UNITED STATES PATENT AND TRADEMARK OFFICE

Office Action Summary

10/697,225

DETAILED ACTION

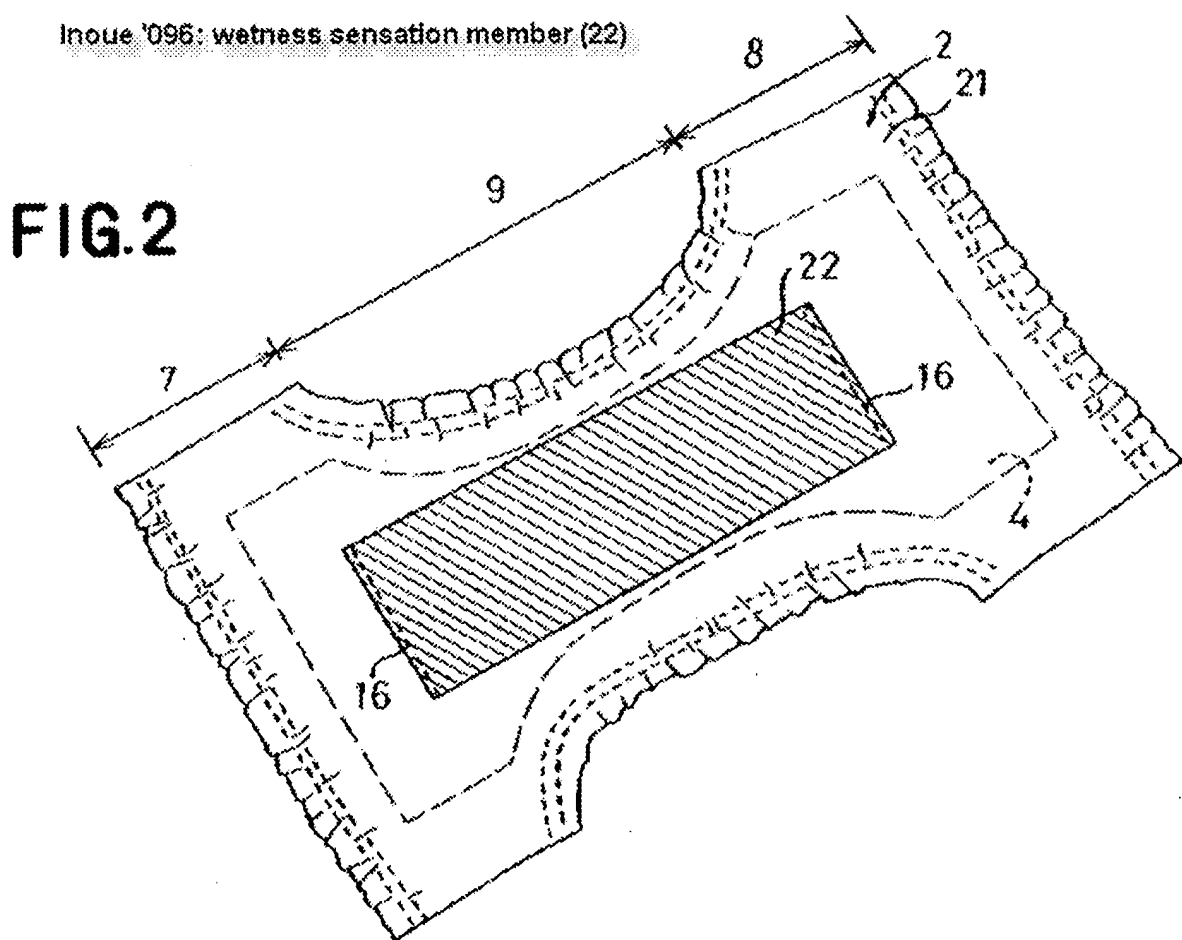
6. As seen in Figures 2 and 3, Inoue teaches a toilet training diaper comprising a wetness sensation member (22) integrated with the topsheet (2). As best depicted in Figures 2 and 3, for purposes of illustration Figure 2 is reproduced below, because the wetness sensation member is a smaller piece of material located on top of the flow control layer (21) and further comprises a different material having different properties and characteristics (c. 2, ll. 30-67 to c. 3, ll. 1-10), the examiner has a reasonable basis to conclude that the wetness sensation member (22) would differ in appearance and therefore would be noticeable from its surroundings, *e.g.*, by differing in coloration, hue, or tint, by differing in lightness, darkness, or contrast, by differing due to the presence or absence of solid color forms, or by any other variation serving to create noticeable visible differentiation, and would be substantially unchanged upon wetting. Additionally, Inoue teaches at c. 3, ll. 58-59 that there is a level difference between the layers, *i.e.* the wetness sensation member layer (22) is raised or in relief above the flow control layer (21).

7. Thus the wetness sensation layer of Inoue would appear different in appearance from the remaining portions of the topsheet and thus meets the definition of visible highlighting as set forth by Applicants and therefore fulfills the claim limitations. Therefore, it would have been obvious to one having ordinary skill in the art at the time the invention was made to form the wetness sensation member of Inoue differing in appearance from the other portions of the topsheet, *i.e.* visibly highlighted, as taught by Inoue in order to provide a visibly noticeable wetness sensation member for toilet training since as long as the member is visible when being viewed, its visibility indicates its presence.
